Reliability Analysis Update

Transmission Expansion Advisory Committee

Tuesday, August 31, 2021

Changes to Existing Projects

AEP Transmission Zone B3139 – B3141, B3220 Replacement

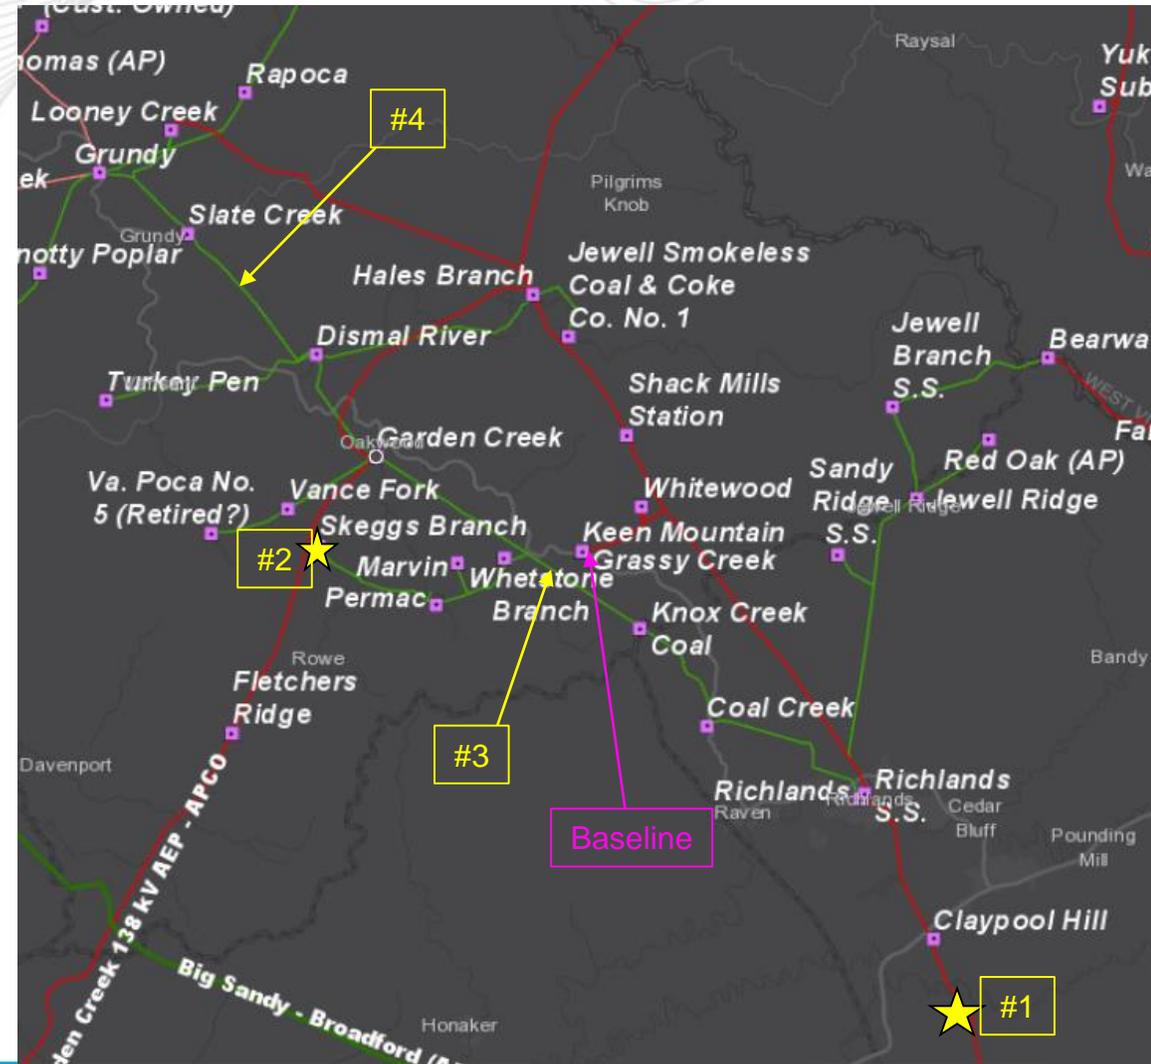
Supplemental Needs identified in the area

1. Salmon substation (AEP-2021-AP003, Needs Meeting 1/15/2021)
2. Skeggs Branch Substation (AEP-2021-AP013, Needs Meeting 3/19/2021)
3. Garden Creek – Richlands – Skeggs Branch 69kV line (AEP-2021-AP014, Needs Meeting 3/19/2021)
4. Dismal River – Grundy – Looney Creek 69kV (AEP-2021-AP002, Needs Meeting 1/15/2021)

Dominion Transmission Zone: Baseline b3246 Scope / Cost Change

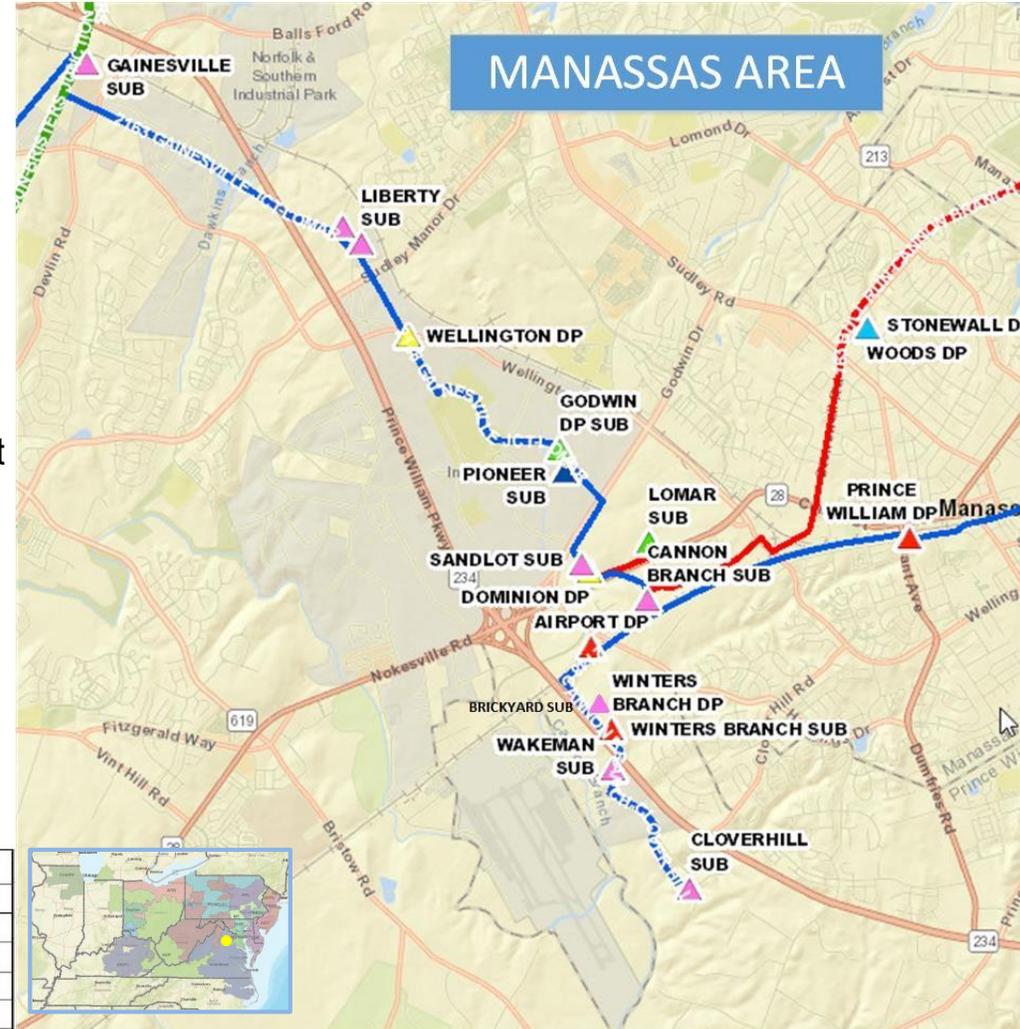
Problem Statement:

- Various load drop violations in the Manassas area greater than 300 MW:
 - The loss of 230kV Line #2195 Cannon Branch-Winters Branch and 230kV Line #2196 Pioneer-Sandlot (N2-SLD5, N2-WLD2).
 - The loss of 230kV Line # 2195 Cannon Branch-Winters Branch and 230kV Line #2148 Cloverhill-Sandlot (N2-SLD6, N2-WLD3).
 - The loss of 230kV Line #2195 Cannon Branch-Winters Branch and 230kV Line #2187 Liberty-Pioneer (N2-SLD7 , N2-WLD1).
 - The loss of 230kV Line#2011 Cannon Branch-Liberty and 230kV Line #2187 Liberty-Pioneer (N2-SLD10, N2-WLD6).

Dominion Transmission Zone: Baseline b3246 Scope / Cost Change

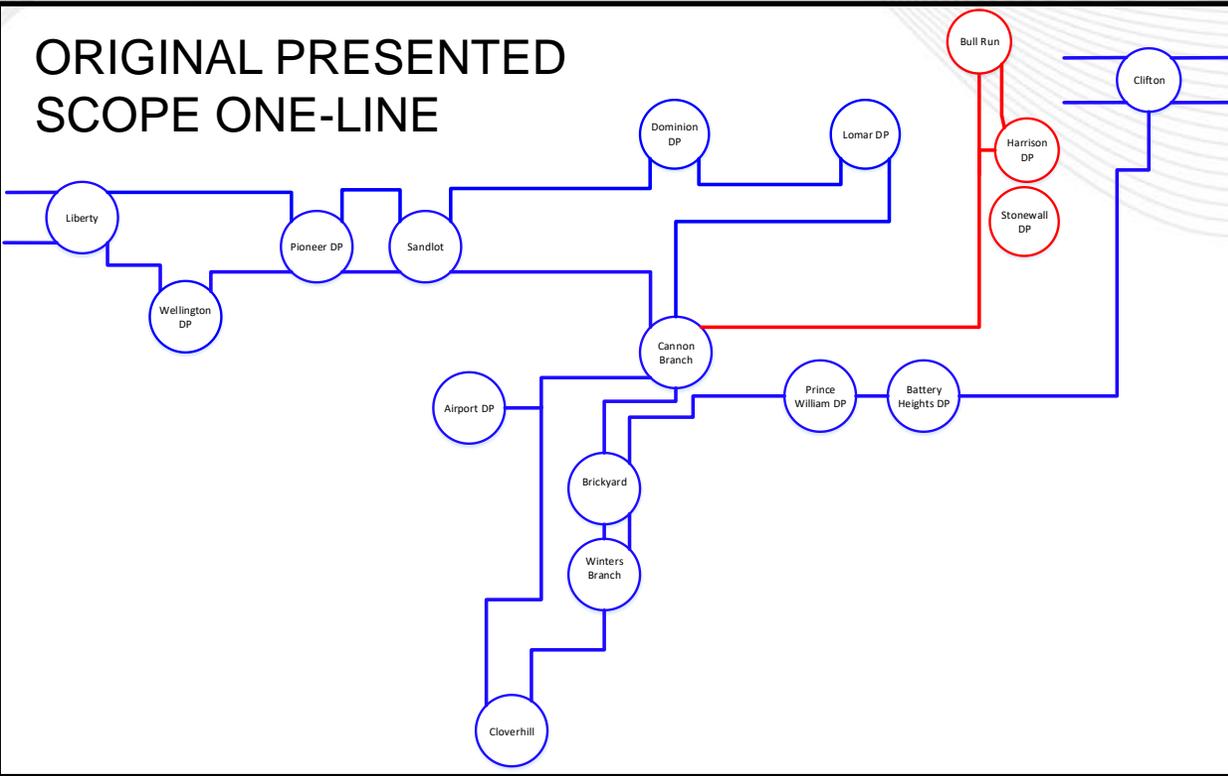
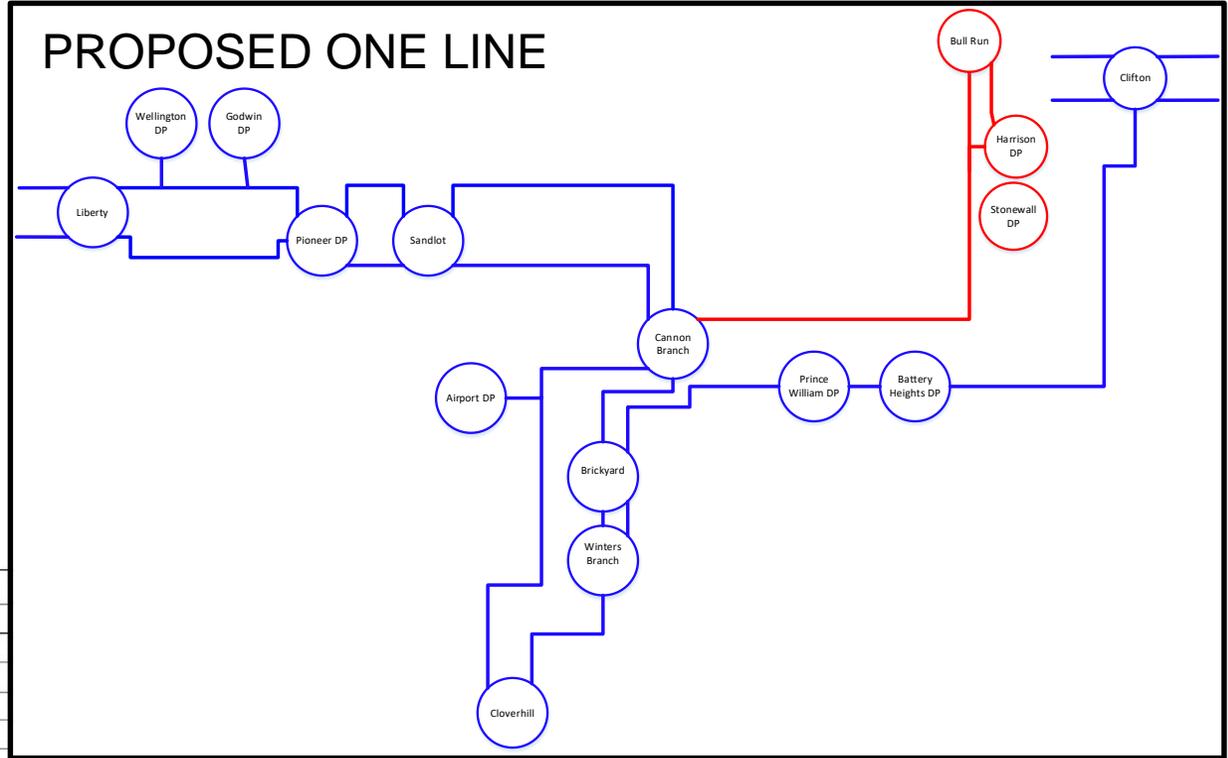
Based on conversations with NOVEC and the City of Manassas Electric Department during the engineering of the original scope it was determined that four Delivery Points required a scope change.

- 1.) NOVEC Wellington and Godwin Delivery Points will be converted vs. retired.
- 2.) NOVEC is no longer planning a New Wellington Delivery Point.
- 3.) The City of Manassas Lomar Delivery Point will be retired with a new DP established at Cannon Branch.
- 4.) The City of Manassas Dominion Delivery Point will be retired and sourced from an expanded Sandlot DP.

The conversion of 115kV Line #172 Liberty-Lomar and 115kV Line #197 Cannon Branch-Lomar to 230kV to provide a new 230kV source between Cannon Branch and Liberty will **not include** the conversion of 0.36 mile segment of line between Lomar and Cannon Branch junction that will be wrecked and not rebuilt (**b3246.1**). Substation work will be required at Liberty, Wellington, Godwin, Pioneer, Sandlot and Cannon Branch. (**b3246.2**).

Extend Line #2011 Cannon Branch – Clifton to Winters Branch by removing the existing Line #2011 termination at Cannon Branch and extending the line to Brickyard creating Line #2011 Brickyard-Clifton and extending a new line between Brickyard and Winters Branch (**b3246.3**). Substation work will be required at Cannon Branch, Brickyard, and Winters Branch (**b3246.4**).

ORIGINAL PRESENTED SCOPE ONE-LINE

PROPOSED ONE LINE
